An  
Bord  
Pleanála

## FSC Report

**ABP-312641-22**

Construction of new 6 storey apartment building with commercial units on ground floor and associated works

Extract - TGDB 1997 Diagram 27

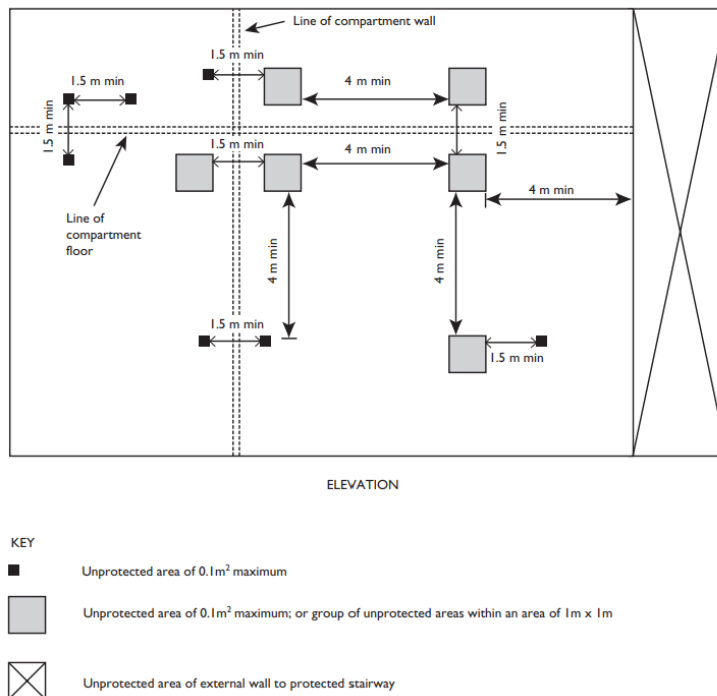
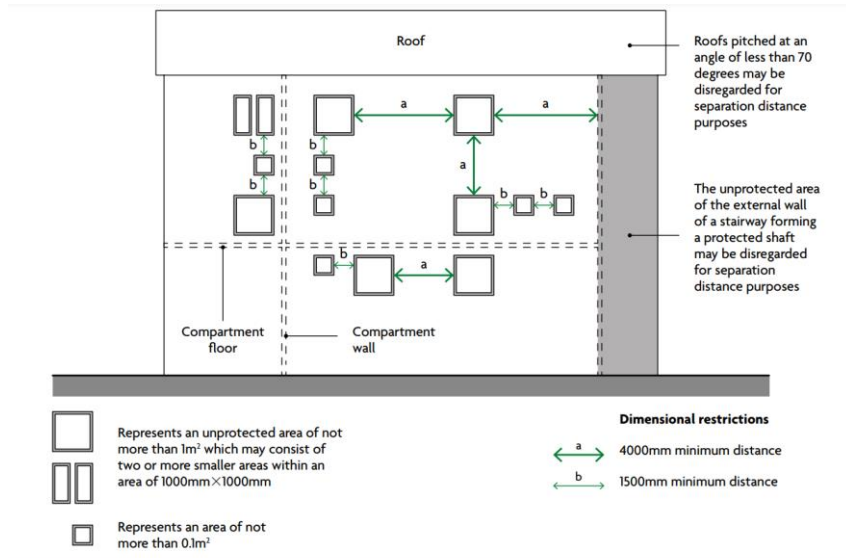
VII. DCC refer to Diagram 27 of TGD B 2006 in Condition 13. Diagram 27 identifies those sections of external wall which can be disregarded for space separation purposes and thus can be installed as non-fire rated walls/windows. There is however an error in Diagram 27 whereby the grey zones are identified as having a maximum area of 0.1sqm. This ought to have read 1.0sqm as per the text in Diagram 27 of TGD-B 1997 which is also the text in the current UK Approved Document B – refer extracts below.

On the basis of the foregoing considerations, I conclude that DCC are justified in imposing Condition 13 although the Condition should have referred to Diagram 27 in TGD-B:1997 and not Diagram 27 in TGD-B:2006.

On the basis of my assessment in 4.0 above I consider that the imposition of Conditions 13 is justified and I consider that An Bord Pleanala should disallow the appeal but direct the Building Control Authority to alter the condition to reference Diagram 27 of TGD-B:1997 in respect of permitted exceptions for the reasons outlined above. Thereby satisfying the requirements of Part B whilst allowing unprotected openings to facilitate ventilation.

*External walls within 1m of the relevant boundary to be fire resisting from both sides (the only permitted exceptions is unprotected areas as described in Diagram 27 of Technical Guidance Document - B:1997). Fire resisting external walls located within 1m of the relevant boundary to be formed from passive in-situ fire rated construction and fire rated per item 5(a) of Table A1 of Technical Guidance Document - B:2006. External walls located more than 1m from the relevant boundary to be in accordance with Section 4.2.8 of Technical Guidance Document – B:2006, any parts of these walls requiring fire resistance to be formed from passive in-situ fire rated construction and fire rated as per item 5(b) of Table A1 of Technical Guidance Document – B: 2006.*
